Newcastle Ocean Baths Stage 2: Coastal inundation assessment

To	Tonkin Zulaikha Greer (TZG) Architects (Wolfgang Ripberger)
Author	T. Fallon
Reviewer	E. Watterson
Reference	P23346_NOBStage2Inundation_R3.00
Date	29 July 2026
Subject	Inundation assessment of Newcastle Ocean Baths Stage 2 Design

Figure 1: Current Stage 2 pavilion and public-domain arrangement (TCL, 2026).

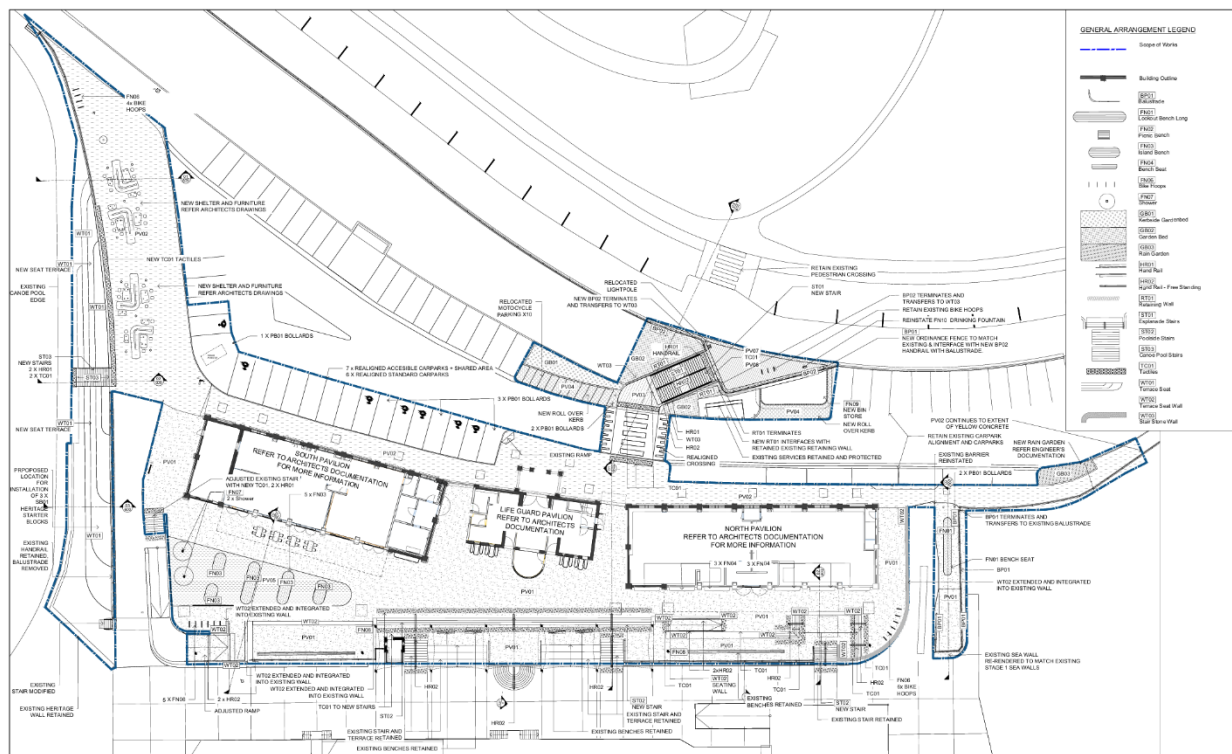
The architectural drawings were reviewed to identify the pavilion footprints, floor and threshold levels, external openings, internal uses, wet areas, service rooms and drainage pathways. The landscape drawings were reviewed to assess the Canoe Pool edge and heritage wall, terraces, stairs, ramps, retaining and seating walls, roll-over kerbs, pedestrian crossing, rain garden, bin store and paved routes between the Canoe Pool, pavilion forecourt and carpark.

The principal external hydraulic controls represented in the model remain materially unchanged. The design amendments do not alter the broader wave transformation and overtopping mechanism but affect the local entry, routing and drainage of water once it reaches the pavilion precinct. The model-derived inundation levels, depths, velocities, discharges and loads have therefore been applied to the current design.

Figure 2: Characteristic 1% exceeded inundation depths at the seaward face of the pavilion buildings.

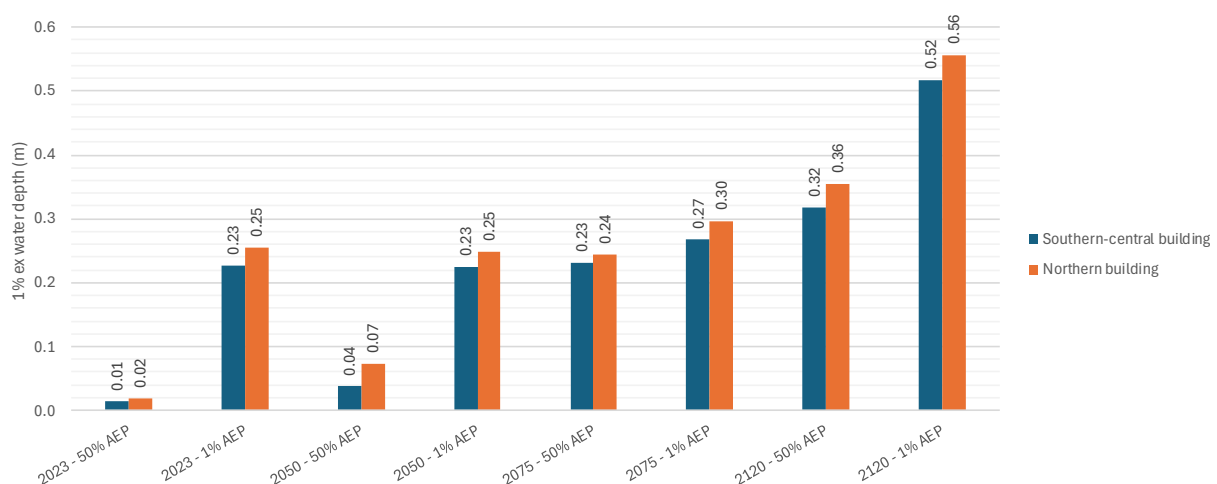
Figure 2 presents the characteristic 1% exceeded inundation depths at the southern-central and northern pavilions. There is limited difference between the two locations for the present-day and 2050 1% AEP scenarios, with characteristic depths of approximately 0.23 to 0.25 m.

A 2075 sea-level-rise scenario of approximately 0.41 m was derived from the modelling results to represent the 1% AEP condition over an indicative 50-year design life. Under this planning horizon, the characteristic 1% exceeded inundation depths are approximately 0.27 m at the southern-central pavilion and 0.30 m at the northern pavilion.

These depths provide the design basis for doors, gates, glazing, temporary barriers, internal drainage, water-resistant finishes and protection of electrical and service infrastructure. The reduced exposure of the pavilion interiors is primarily attributable to the increased finished floor level and the arrangement of the pool edge, pavilion deck and surrounding public-domain levels represented in the numerical model.

Figure 3: Inundation depths at the Bath's main switch board.

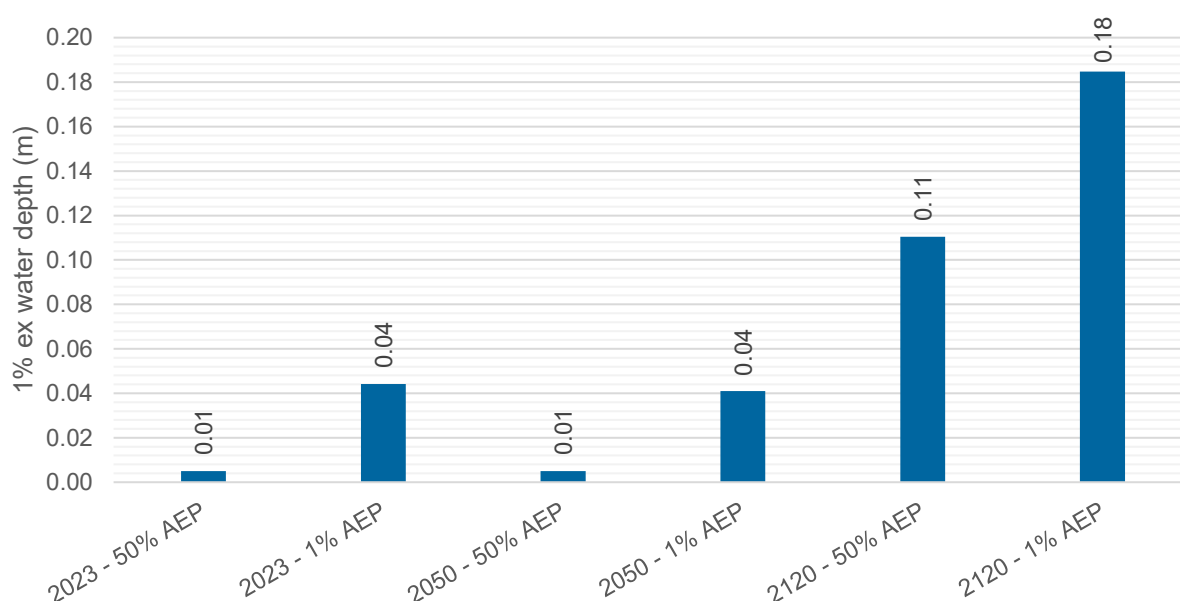
The main switchboard (MSB) is located on the landward side of the carpark near the opening between the northern and central buildings. The MSB sits on a concrete plinth approximately 0.3 m above ground level. Sensitivity testing undertaken in Stage 1 was used to determine 1 % exceedance water levels at

this location, as the inclusion of the modelled buildings is essential to capture accurate inundation behaviour. As such, the results from the Stage 1 modelling were used to derive these inundation depths. The results (Figure 3) indicate that even under the 2120 planning horizon, inundation depths remain below the base of the MSB enclosure. However, vertical splashing and local run-up may still occur during extreme events, and the MSB housing should therefore be constructed to an appropriate weathertight standard.

The current design also includes a ground-floor communications switch room and associated plant within the central pavilion. Water-sensitive equipment should be elevated above the adopted design inundation level, installed in suitably rated enclosures and separated from adjoining wet-area drainage paths. Cable and service penetrations should be sealed, and the services design should include appropriate isolation and post-event inspection procedures.

Figure 4: Mean water ingress rates (L/s/m) for the northern pavilion change door entrance for modelled scenarios.

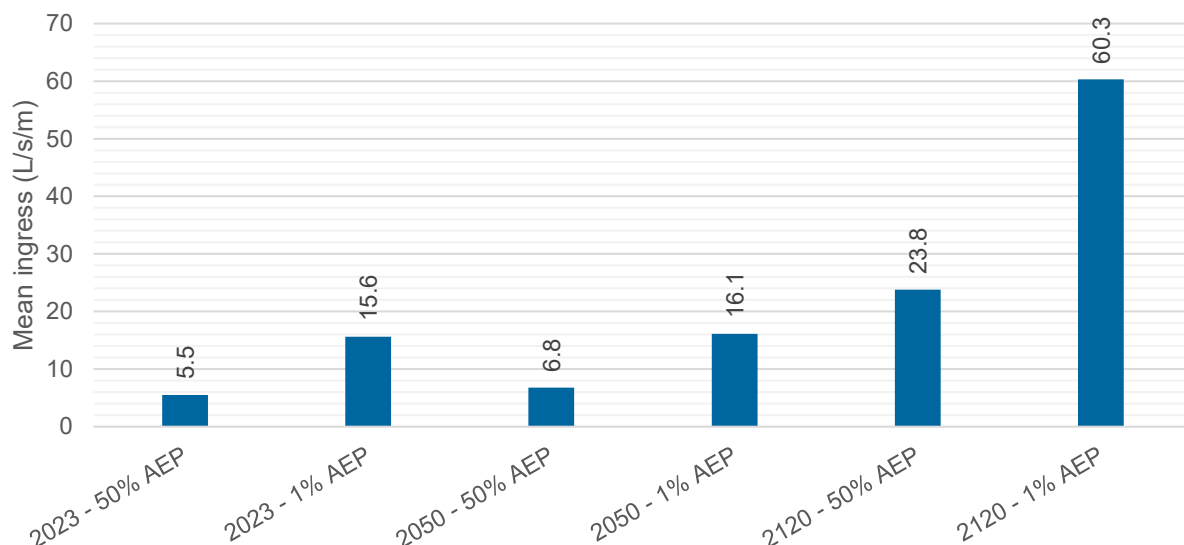
The northern pavilion contains a principal seaward-facing entrance to the male and female amenities. The security gate or grille at this entrance will not prevent water ingress during overtopping events.

Model outputs were used to calculate potential water-ingress rates from the time-varying water depth and flow velocity immediately in front of the entrance. The calculated mean unit ingress rates range from approximately 5.5 L/s/m for the present-day 50% AEP condition to 60.3 L/s/m for the 2120 1% AEP condition. The applicable unit rate should be multiplied by the final clear opening width to establish the design inflow rate.

The northern amenities should be treated as wet and semi-open marine spaces. The drainage design should account for inflow through the principal seaward entrance and lower northern end entry, wind-driven rain and salt spray beneath the canopy, distributed floor falls, local ponding behind cubicles, sump and pump capacity and prevention of backflow from external drainage systems.

Internal walls, thresholds and drainage should prevent water entering the amenities from migrating into the central pavilion, communications switch room, plant rooms or other water-sensitive spaces.

Figure 5: Possible temporary wave barrier layout on seaward façade of Southern building (indicative only).

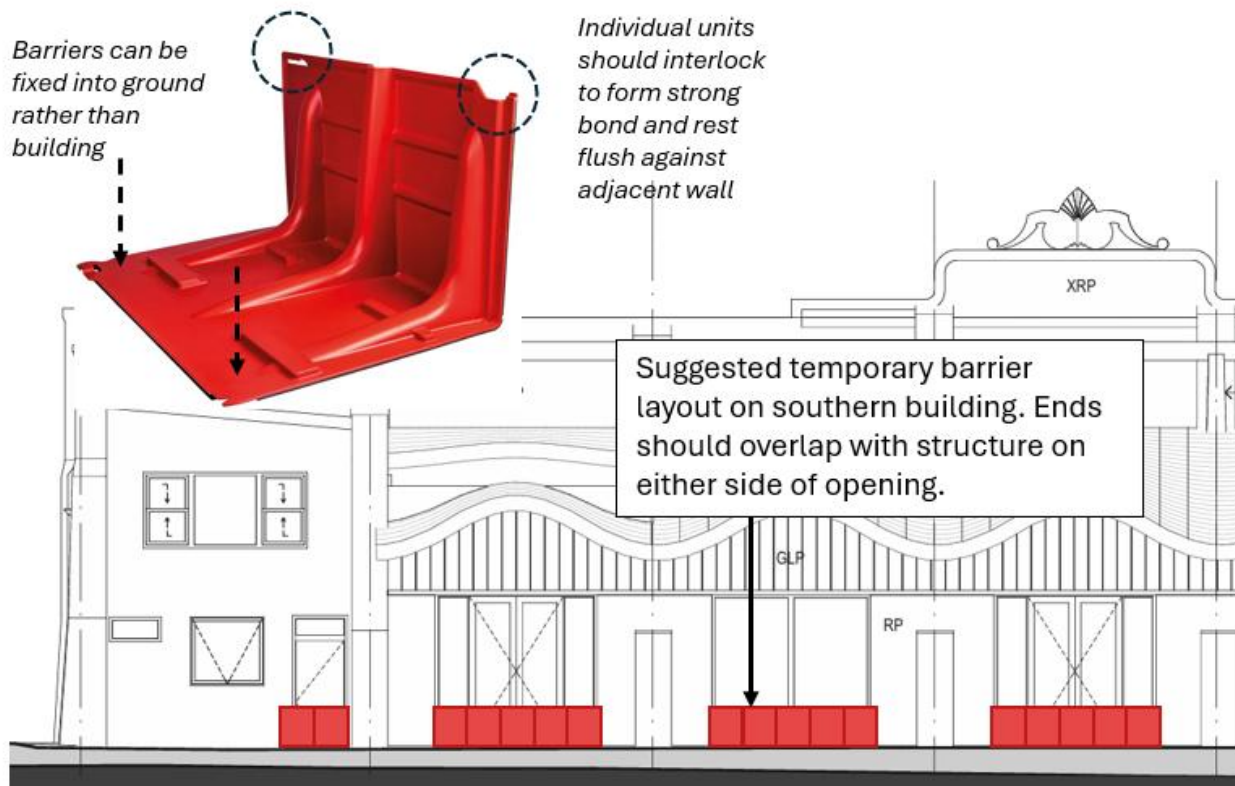
Temporary barriers are recommended at vulnerable seaward-facing openings in the southern pavilion and may also be appropriate at the lower northern entry.

Under the 1 % AEP (2050 + SLR) scenario, the modelled overtopping depth at the pavilion deck is approximately 0.25–0.30 m. Installation of modular barriers would prevent direct ingress through doors and openings for all events up to this design condition. Residual splash and seepage can be managed through internal drainage and sump pumps, providing effective operational protection without the need for permanent structural modification.

The selected system should be designed for the adopted water depths and wave-induced flow conditions. The detailed design should identify the barrier extent and height, restraint and fixing arrangement, storage location, deployment access, inspection requirements and compatibility with accessibility and normal door operation.

Proprietary barriers intended for low-velocity floodwater should not be assumed to be suitable without verification. Additional restraint or a project-specific mounting system may be required.
